This submission is a response to your telephone request for further information for Purdue University Broad Scope License 13-02812-04 for use of Cd-109 in human research studies.

1. Request for Additional Information

2. Request for Additional Information Regarding Appendix F

The source holder (left without source) and the shutter or shield that will be in place when not acquiring data.

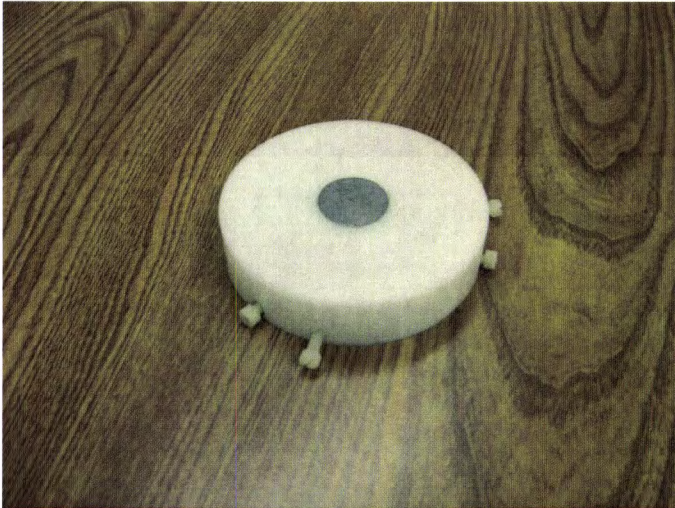
1.4 Please provide a description of the components, in terms of physical design, used to mount the source in front of the HPGe detector (Page 2).

The source is mounted in a plastic holder- it is currently secured by tape. A set screw will be installed to hold the source in position during use. The plastic holder is then secured to the face of the germanium detector crystal by set screws.

Source shutter (cover) in place. Center portion is approximately 3 mm thickness of lead which attenuates greater than 99% of photons.

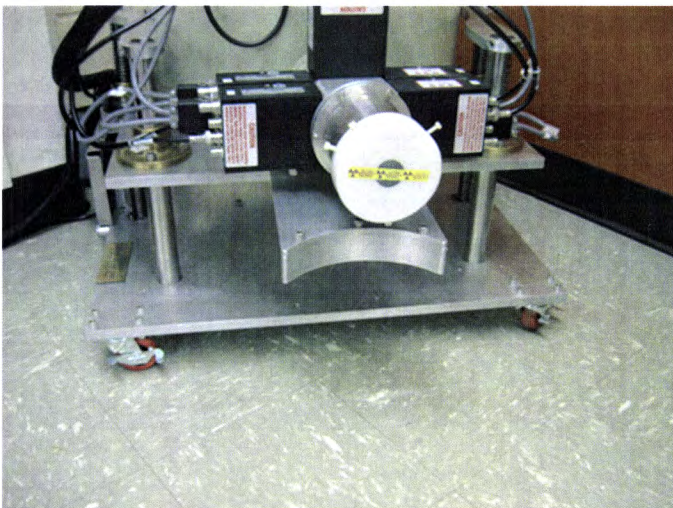
2.6 Please describe whether the beam is always 'on'. If not, describe how shielding or shutter use is accomplished.

The shutter is shown in the response to question 1.4. During the measurement process the principal investigator or designee will be present at all times. There is no hazard from the equipment if an individual were to tamper with the device (e.g. high voltage); however, each subject will be observed and instructed not to touch any equipment. The liquid nitrogen dewar which is required for operation will be filled only when no research subjects are present. There is no hazard to the research subjects during operation.
